DIVISION OF RECLAMATION
MINING AND SAFETY

Lombard 4&5 Adequacy Review Doc.

MINE PLAN MAP
(Optional template)

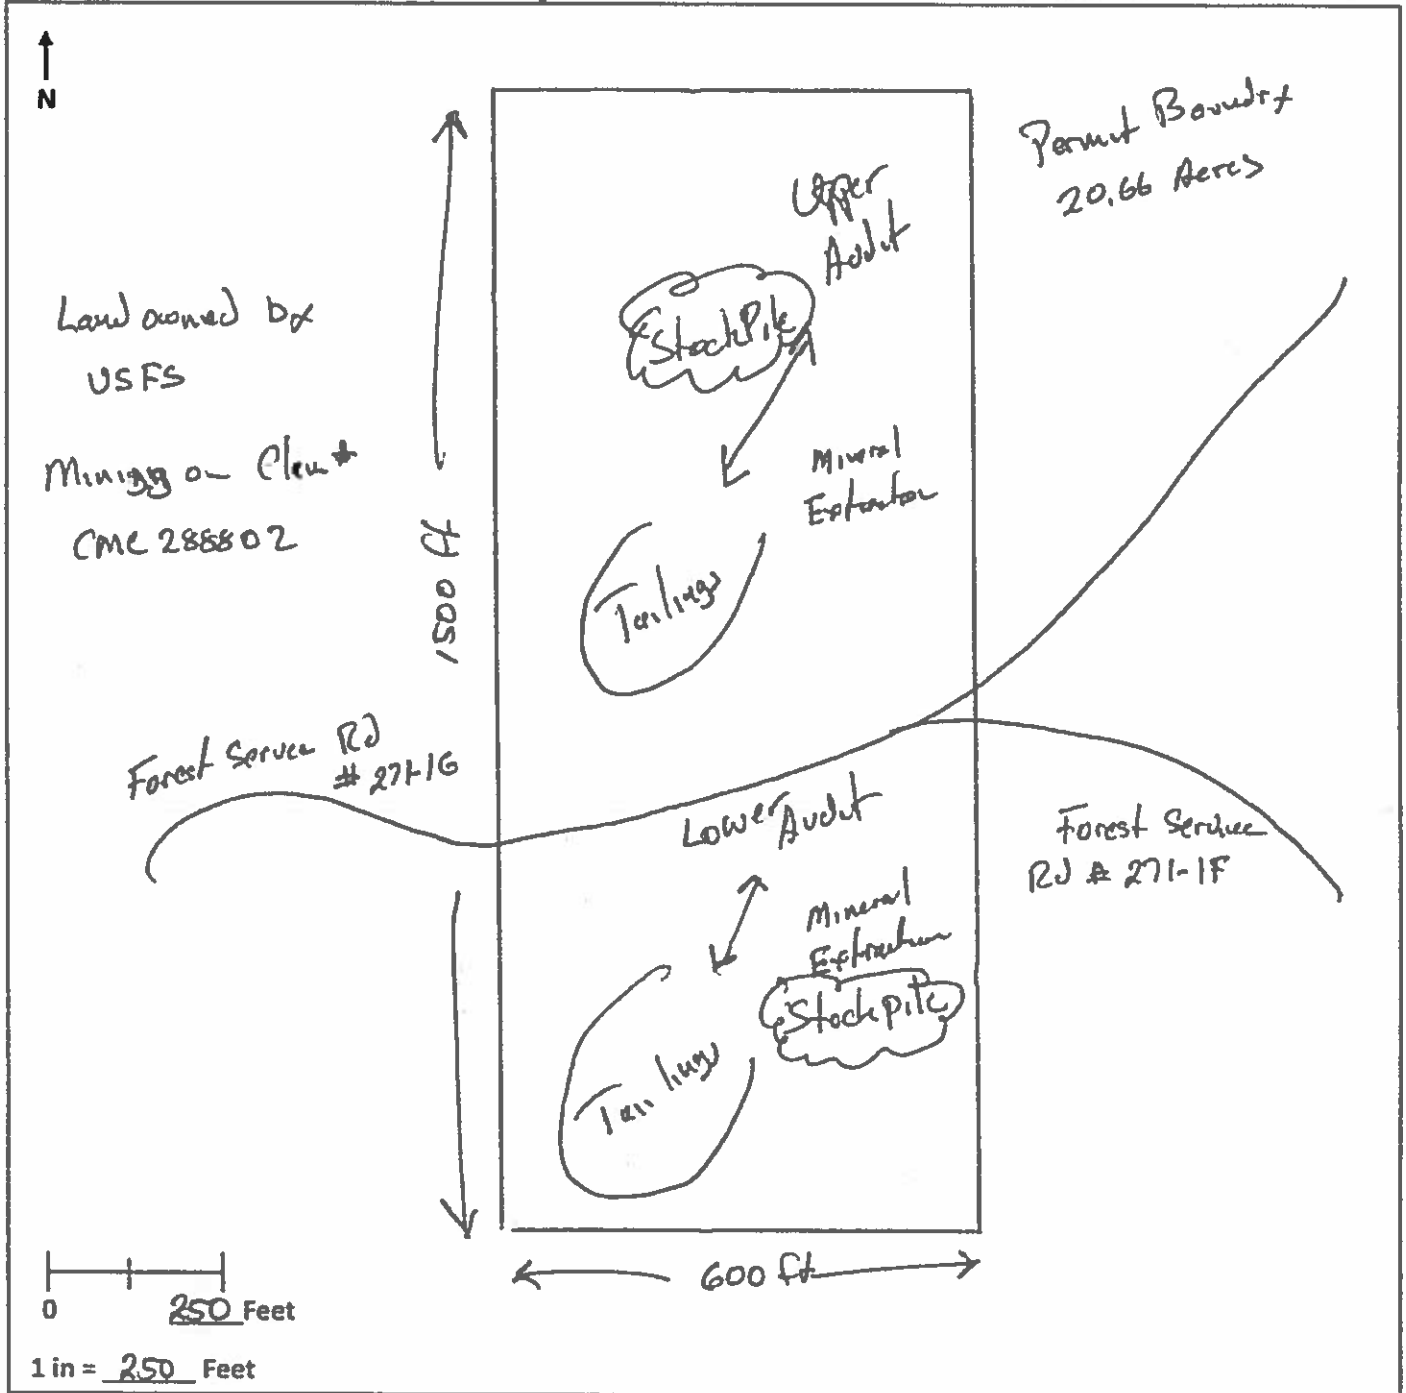
11. Stockpile locations added to mining map
12. Exposed audits will either be gated or backfilled.
13. Road dimensions are 10' wide by 750' long
14. Tailing piles are waste rock

RECLAMATION PLAN MAP (Optional template)

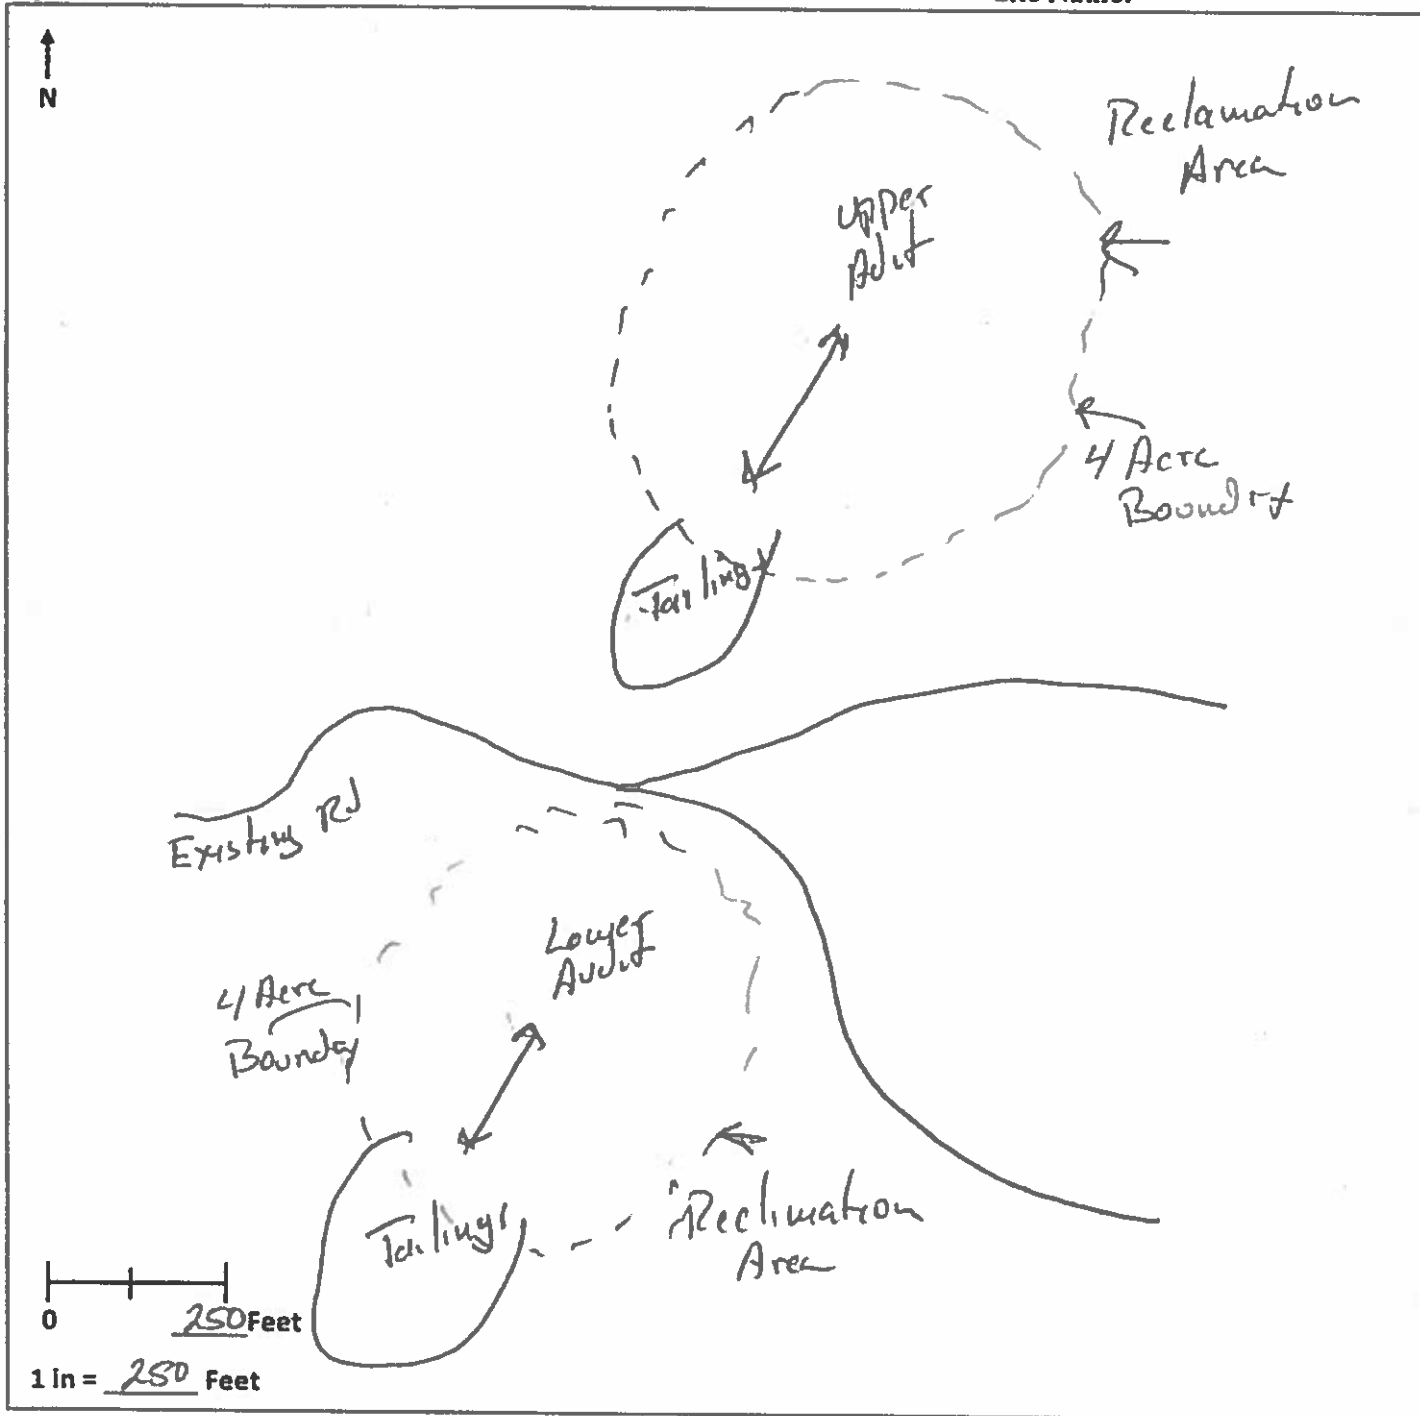
27. 4 acre permit boundary added
28. Topsoil and overburden stockpiles shown on reclamation map.
29. The words Upper and Lower have been added to reclamation map
30. 4 Acre boundary added
31. Reclamation map scale added
32. Applicant name added to reclamation map
33. Shown on Map
34. The topsoil is ½" to 3" Shown on Map
